Informal document No. GRSG-95-24  
(95th GRSG, 21 – 24 October 2008  
agenda item 3(e))

## **Bus & Coach directive** (2001/85/EC)

*Would such a vehicle configuration obtain  
a type-approval certificate in your country?*

**Type Approval Authorities Meeting**  
Edinburgh, 9-10 October, 2008

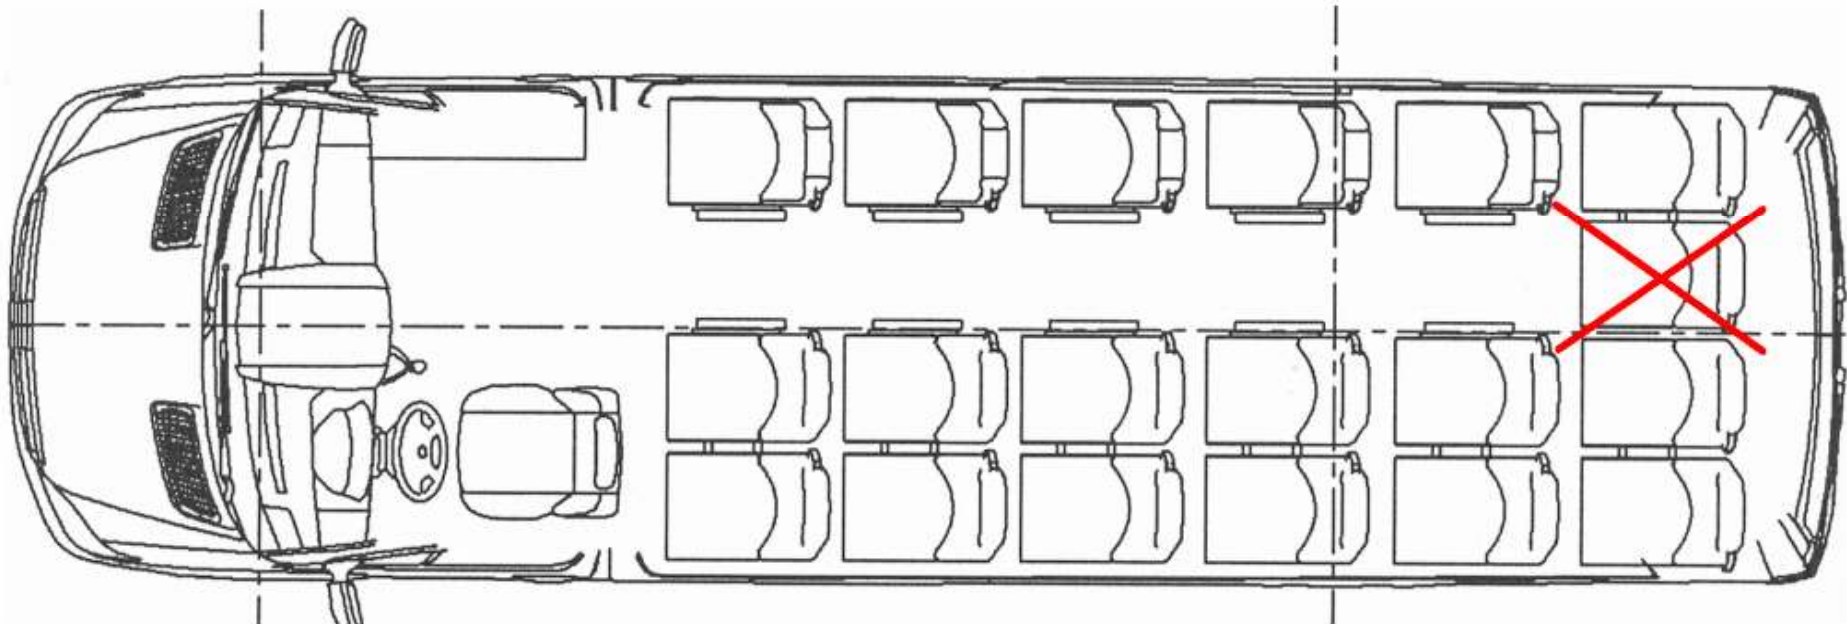
**Should the driver’s door be considered as an emergency  
door or emergency exit?**

**The driver's door should ONLY be considered as an emergency EXIT.**

**The emergency DOOR should provide an unobstructed way of evacuation. In case of a roll-over or tip-over accident (as presented), a vehicle in question does not provide such life-saving provision. The service door is blocked, the driver's door is very hard to open from the inside and the driver, if dead or injured, is an obstacle that is quite impossible to pass.**

**So, the driver's door should ONLY be considered as an emergency EXIT, i.e. a secondary means of evacuation, like an escape hatch that is just another example of emergency exit.**

**This requirement is also not met by the vehicle in question.**

**The vehicle configuration in question should NOT obtain a type-approval certificate.** That should only be possible if there is a free access to the rear door that would then be the emergency door, i.e. by removal of one seat from the rear row.
